From: [REDACTED]
To: [Hornsea Project Three](#)
Cc: [Sarah Drljaca](#)
Subject: Registration Number 20010316 - Oulton Parish Council's submission to PINS at Deadline 7
Date: 14 March 2019 11:16:39
Attachments: [Orsted Deadline 7 APPENDIX 1-VISSIM screenshots.docx](#)
[Orsted Deadline 7 Appendix 2-AIL Table.xlsx](#)

Hornsea Project Three

Oulton Parish Council (OPC) welcomes this opportunity to comment on the current status of traffic and environmental issues since Deadline 6, the ASI on March 5th and the Issue Specific Hearing on March 8th.

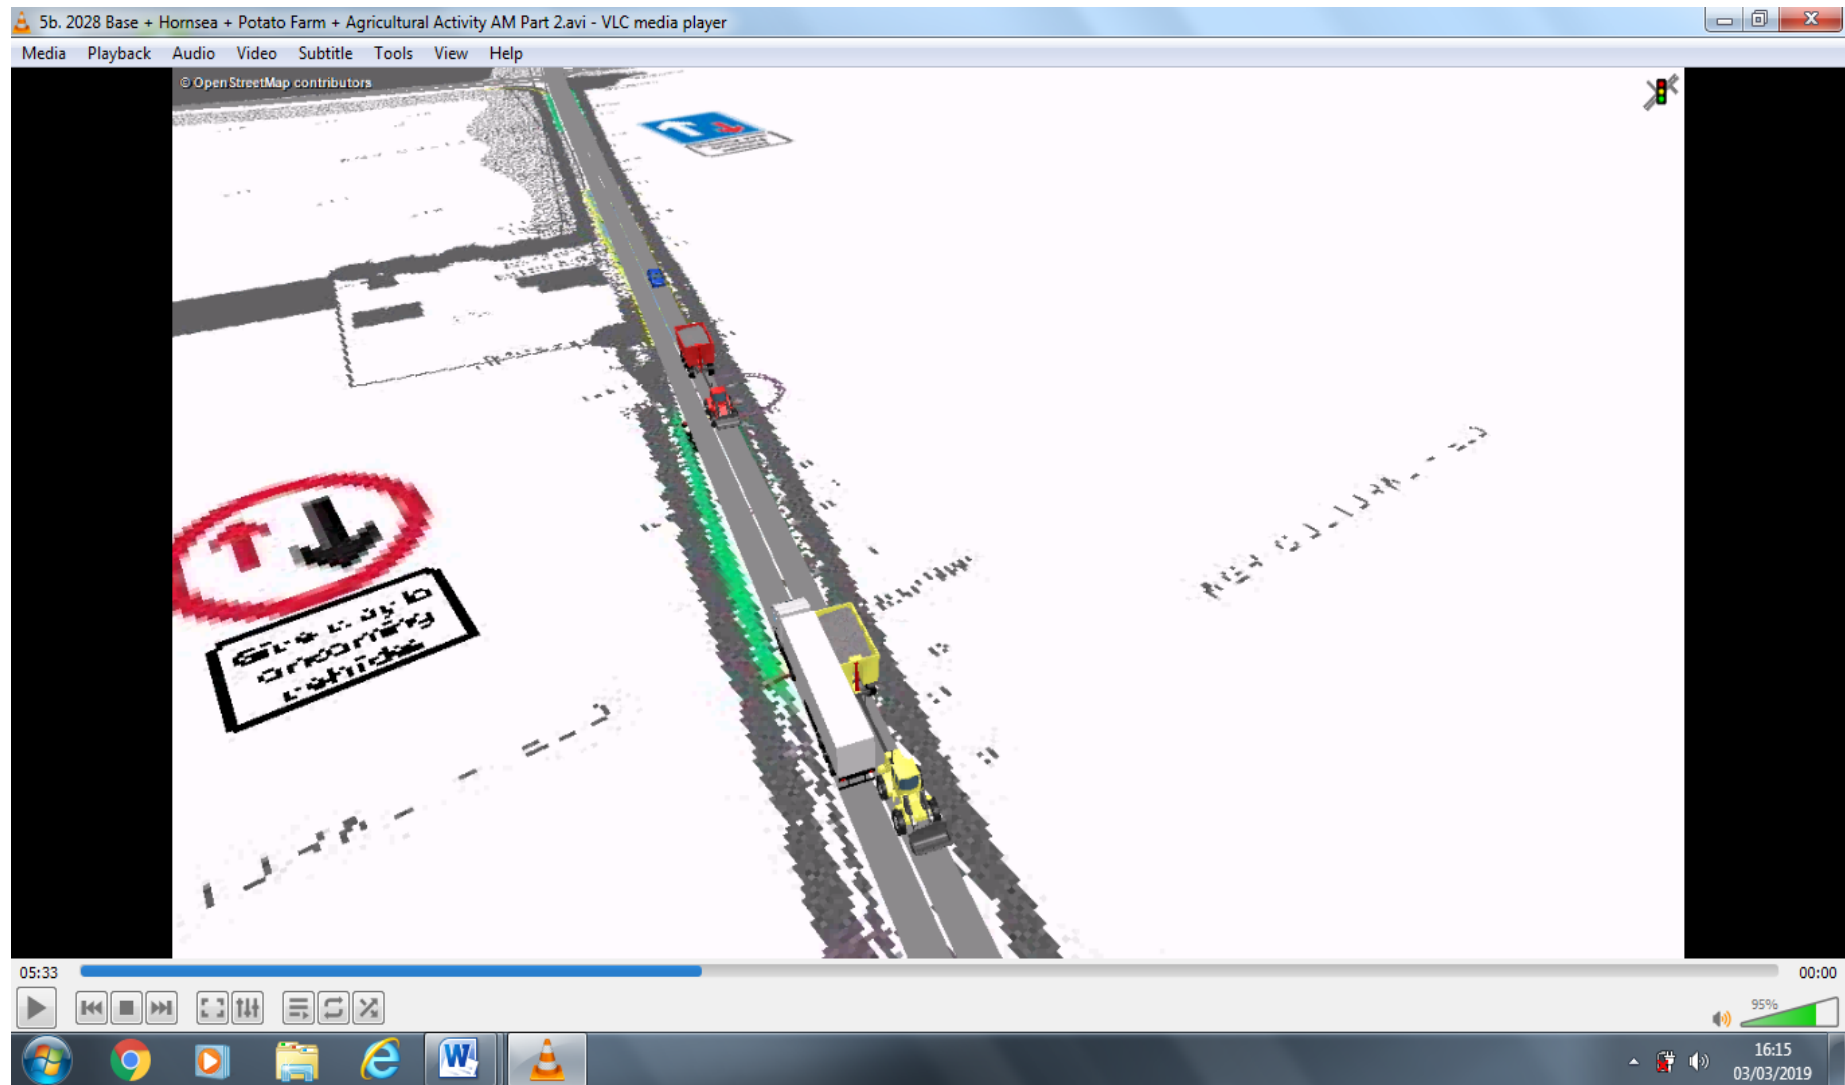
*Priority signs at the hump next to the Railway Gatehouse not working: it would not be possible for two tractor/trailers or HGVs to pass at this point. The road width at this point is planned to be the same as currently.

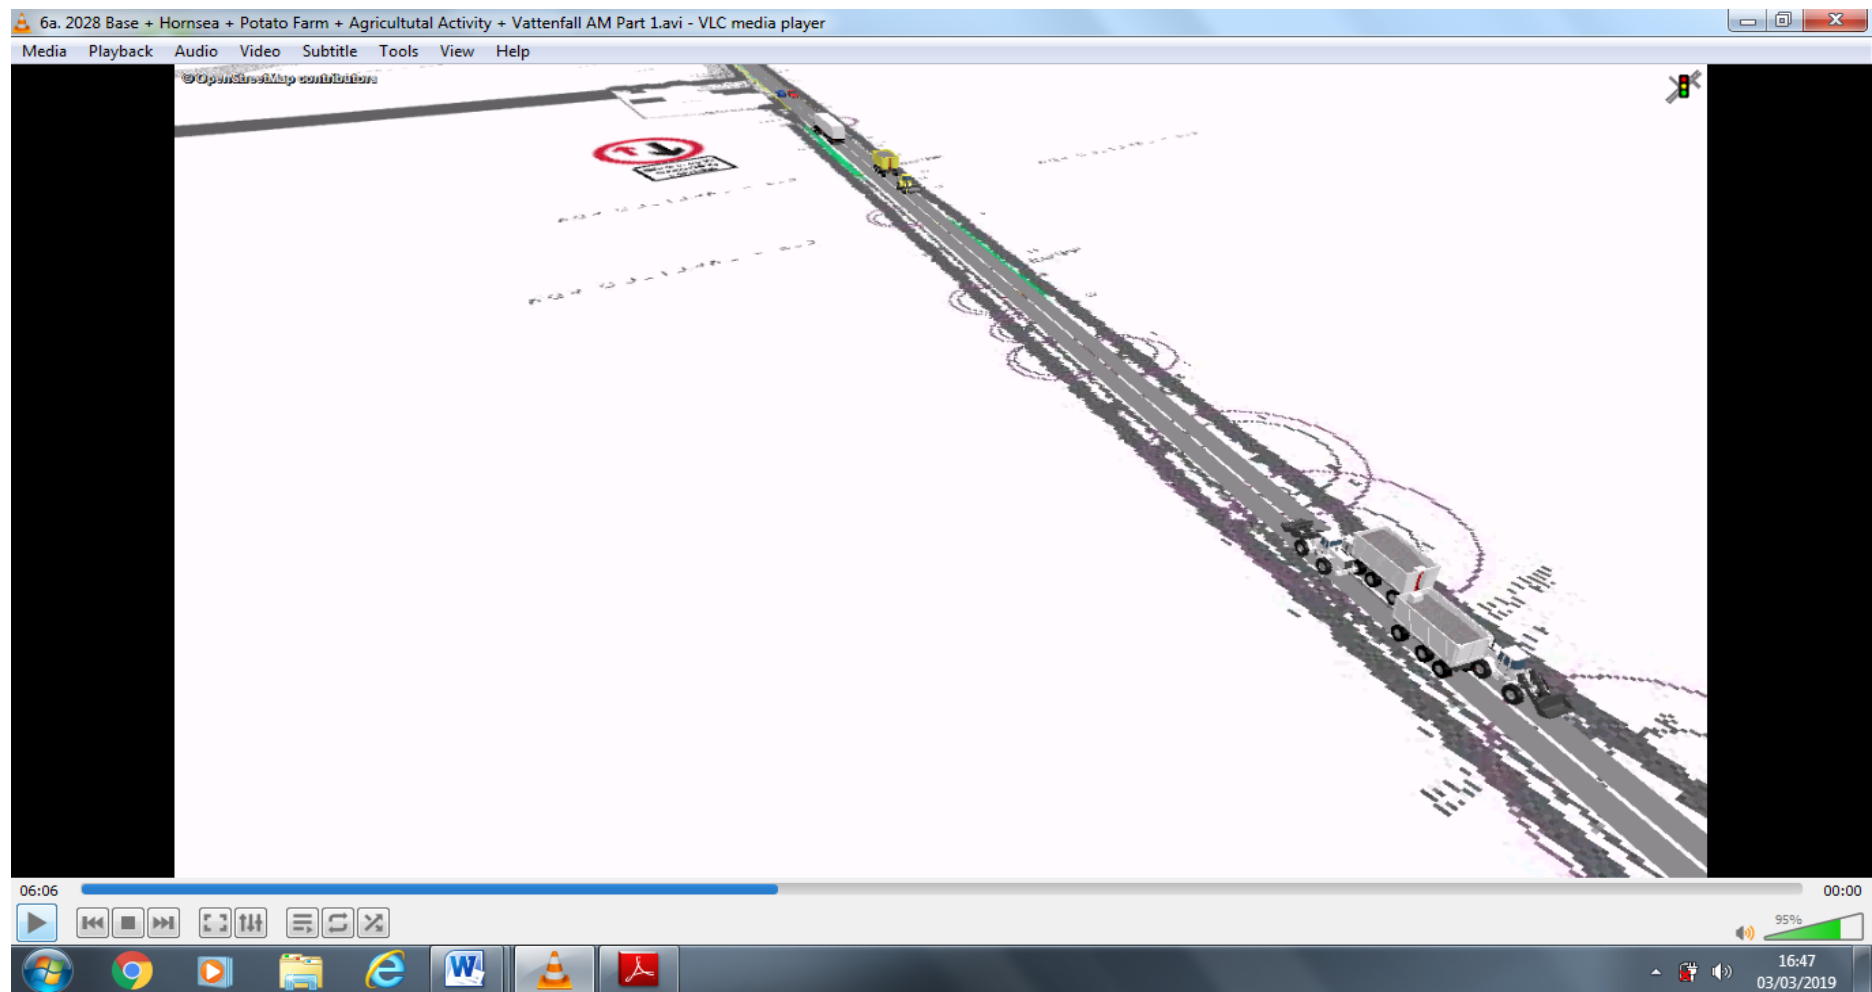
Data input error: one HGV and one tractor/trailer passing each other without use of passing place. This is impossible - the road is too narrow.

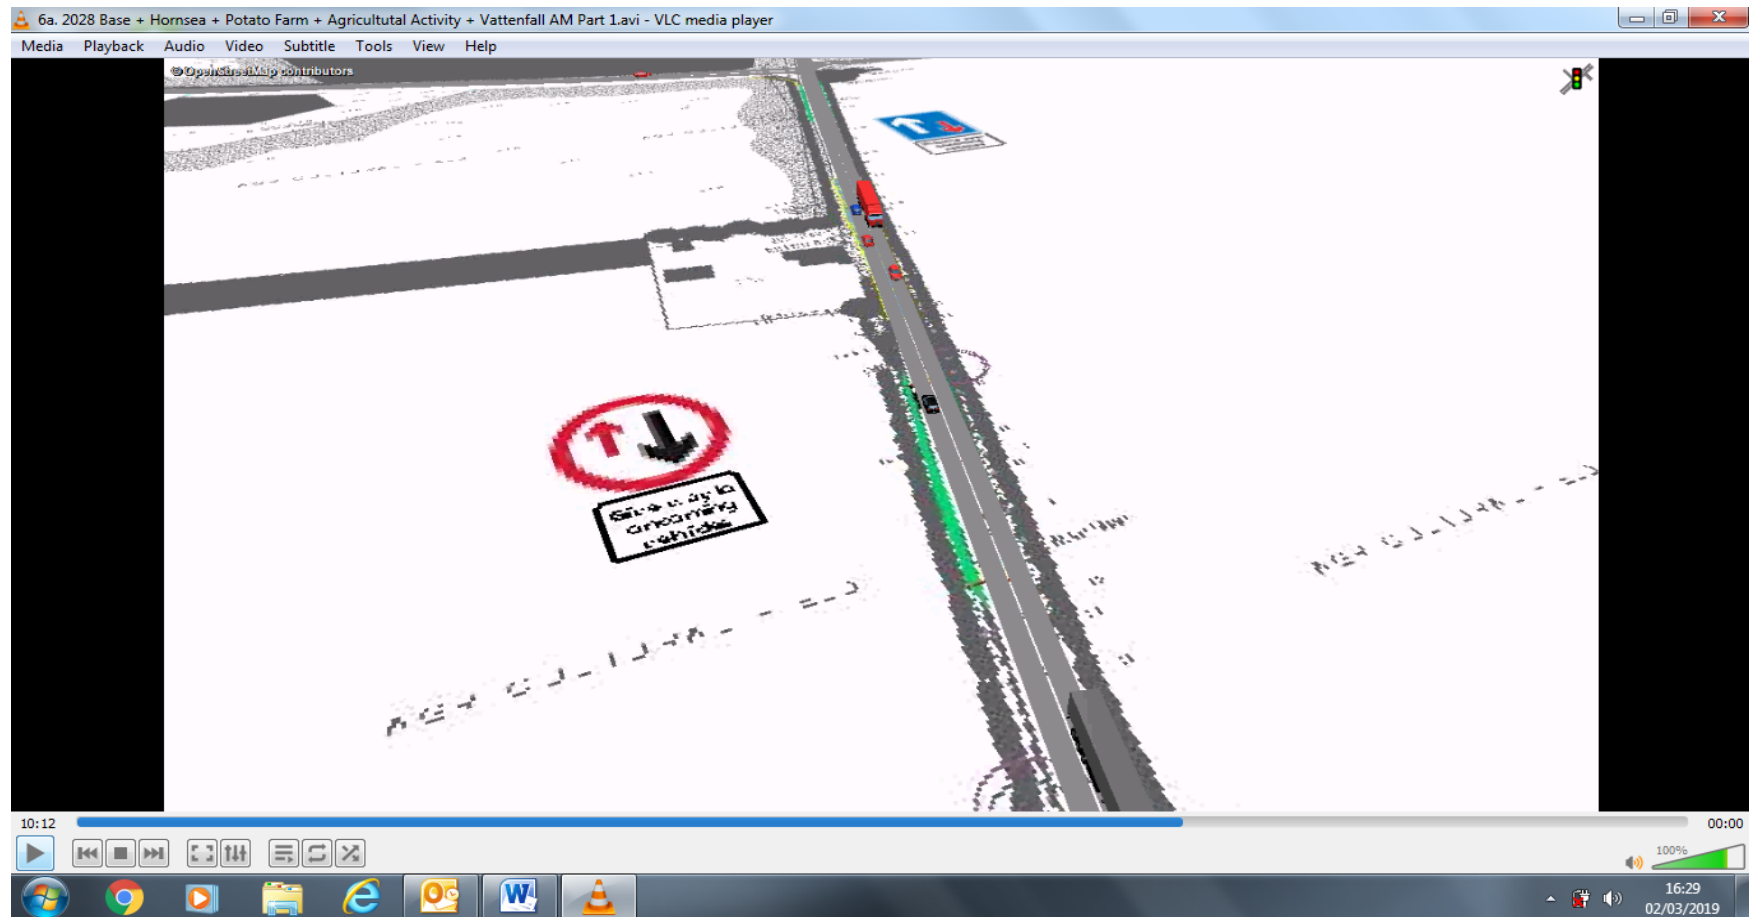
Two tractor trailers passing outside of passing places – this is impossible.
[6a 2028 Base + Hornsea + potato Farm + agricultural activity + Vattenfall AM part 1.]

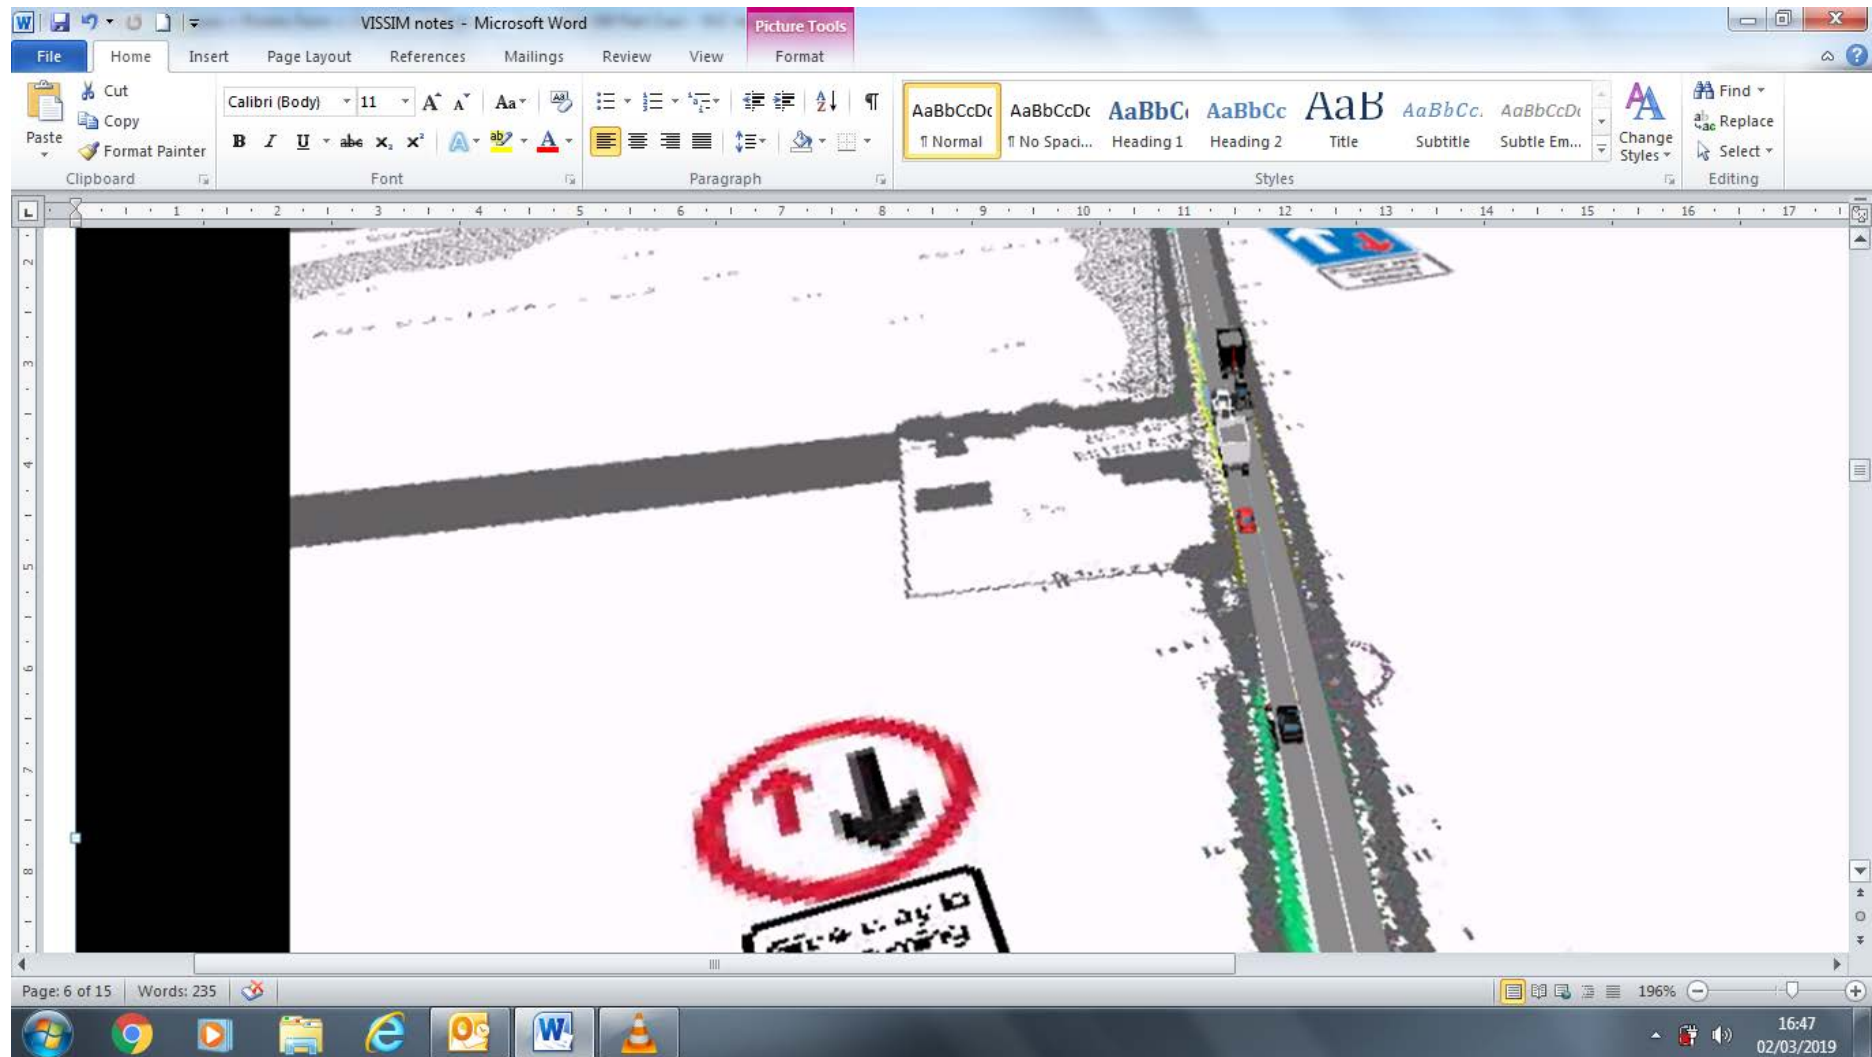
Priority signs not working at the hump: it is impossible for an HGV and a car to pass at that location.

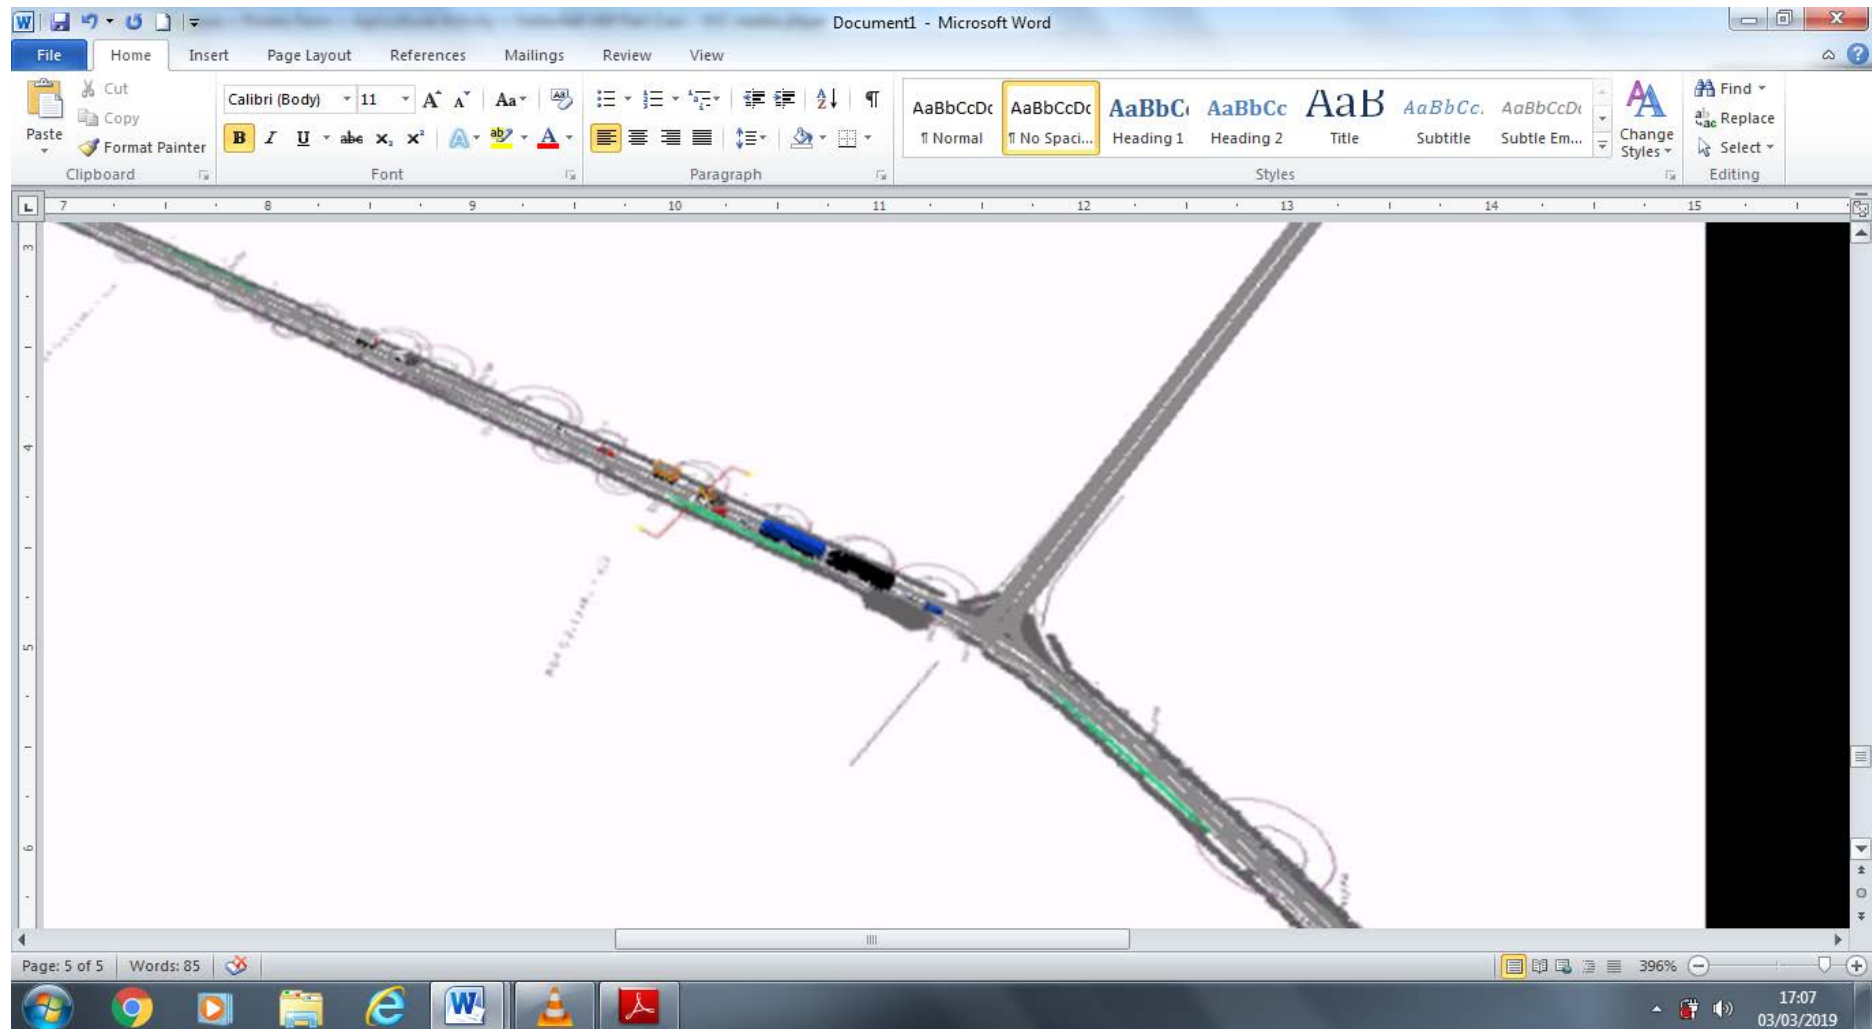
(ABOVE) Two tractors outside old railway gatehouse, potential for vehicles to overrun side of road and, in any case, the road width proposed makes such a passing impossible.

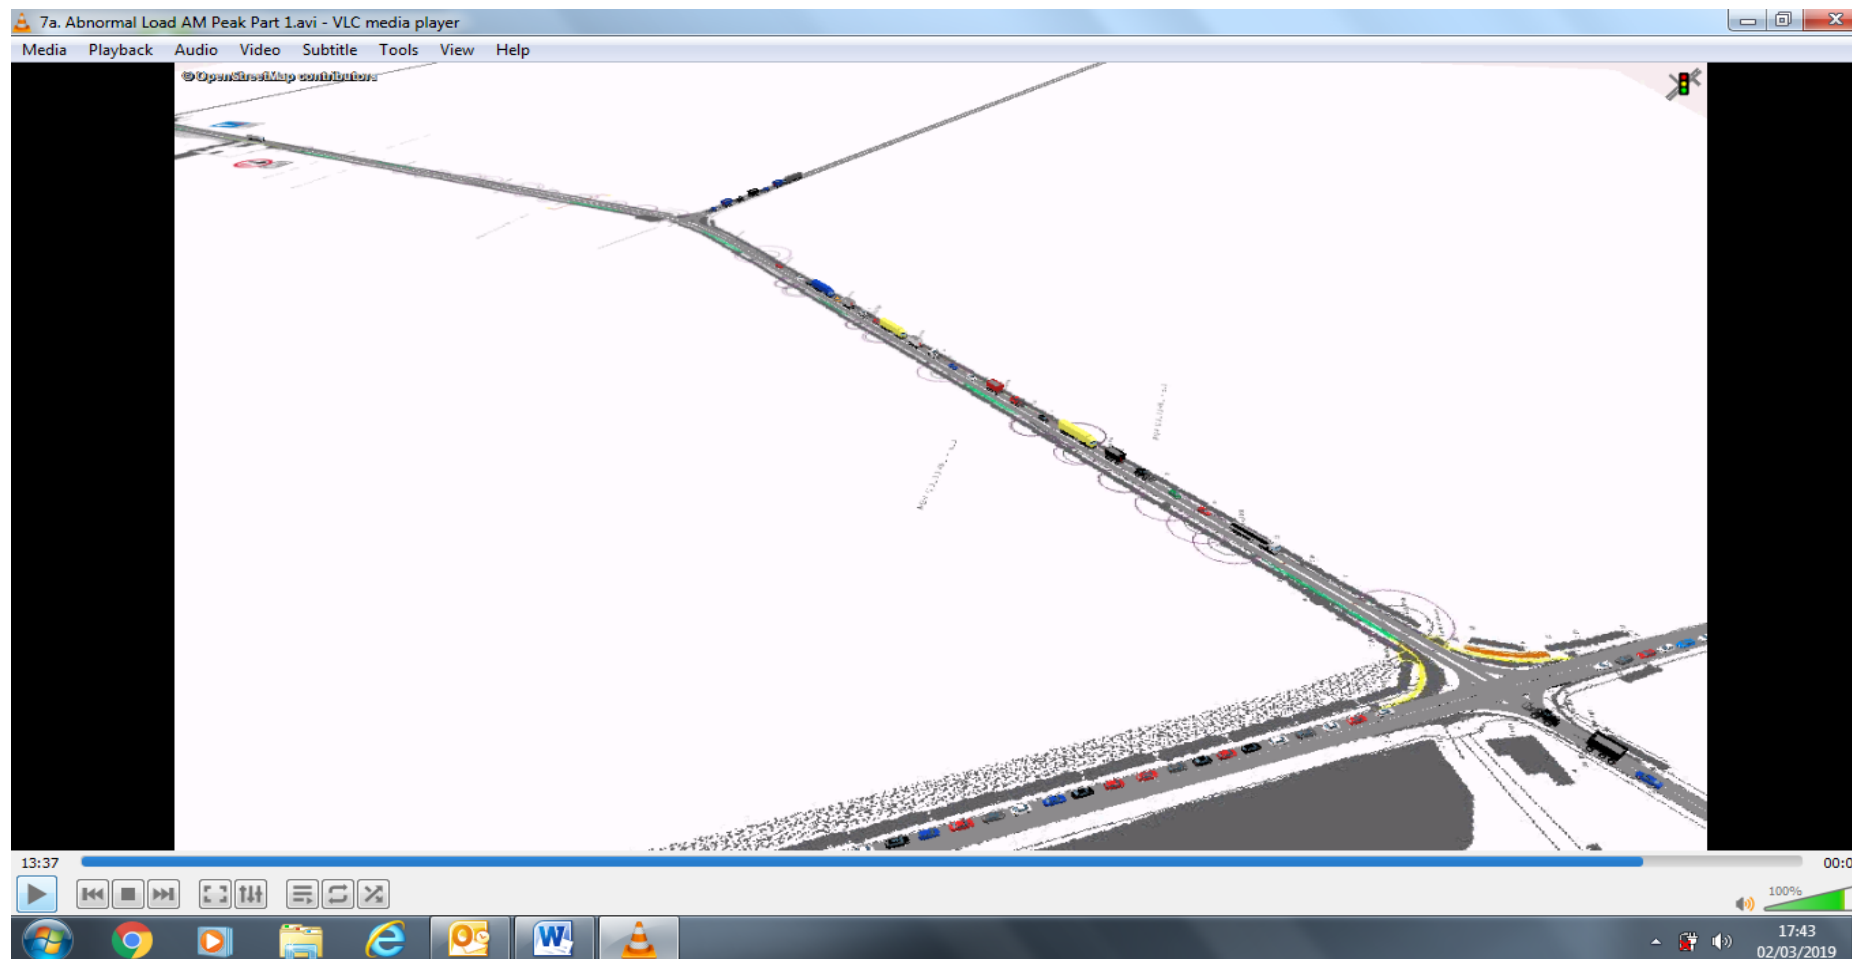
(Above) Enlarged view of bend. [6b 2028 Base + Hornsea + Potato Farm + Agricultural activity + Vattenfall AM part 2]...shows 2 cars 1 HGV in passing place
1 HGV & 2 Cars outside of passing place at bend, waiting for oncoming traffic.(3.33sec)
